Access Compliance Report

Public Rights-of-Way

Intersection ID: 15859	Main Street: MONROE RD	Cross Street: MCALWAY RD	Location: NE
ADA ID: C527447CA84A	Ramp Type: Perp	Initial Pass/Fail: Fail	Overall Compliance: No
		Severity Score: 12.5

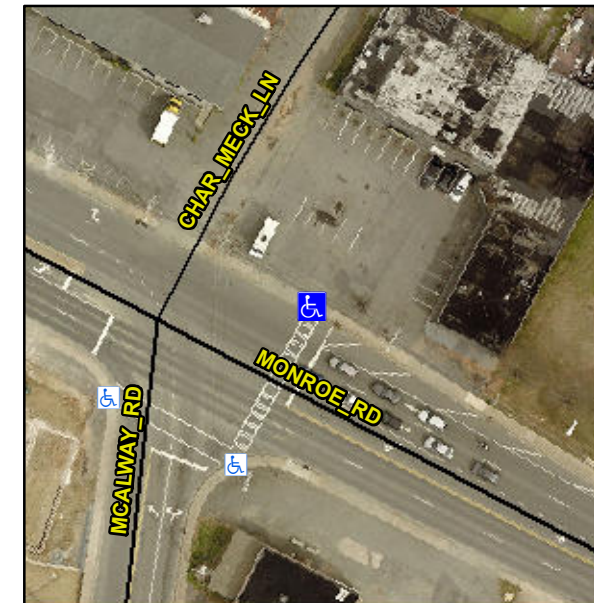
Not Found, R304.2.2

Compliance	Description	Data	Compliance	Description	Data
N/A	Ramp Length (in)	60.0	No	Ramp Slope (%)	8.8
Yes	Ramp Width (in)	48.0	Yes	Ramp XSlope (%)	0.6
N/A	Flare Type LT	N/A	N/A	Flare Type RT	N/A
N/A	Flare Slope LT (%)	N/A	N/A	Flare Slope RT (%)	N/A
N/A	Flare Traversable LT?	N/A	N/A	Flare Traversable RT?	N/A
N/A	Landing Length (in)	N/A	N/A	DWS Provided?	N/A
N/A	Landing Width (in)	N/A	N/A	DWS Contrast?	N/A
N/A	Landing Slope (%)	N/A	N/A	DWS Length (in)	N/A
N/A	Landing X Slope (%)	N/A	N/A	DWS Full Width?	N/A
N/A	Landing Curb? (Y/N)	N/A	N/A	DWS Offset (in)	N/A
N/A	Shared Landing?	N/A			
N/A	Gutter Ponding?	N/A	N/A	Gutter Slope (%)	N/A
N/A	Gutter Lip Ht (in)	N/A	N/A	Gutter X Slope (%)	N/A
N/A	Painted X Walk1?	Yes	N/A	Painted X Walk2?	N/A
	X Walk 1 Direction	To SW		X Walk 2 Direction	N/A
N/A	X Walk 1 Width (in)	82.0	N/A	X Walk 2 Width (in)	N/A
	X Walk 1 Slope (%)	1.4		X Walk 2 Slope (%)	N/A
	X Walk 1 X Slope (%)	0.8		X Walk 2 X Slope (%)	N/A

Remove & Replace Entire Ramp.
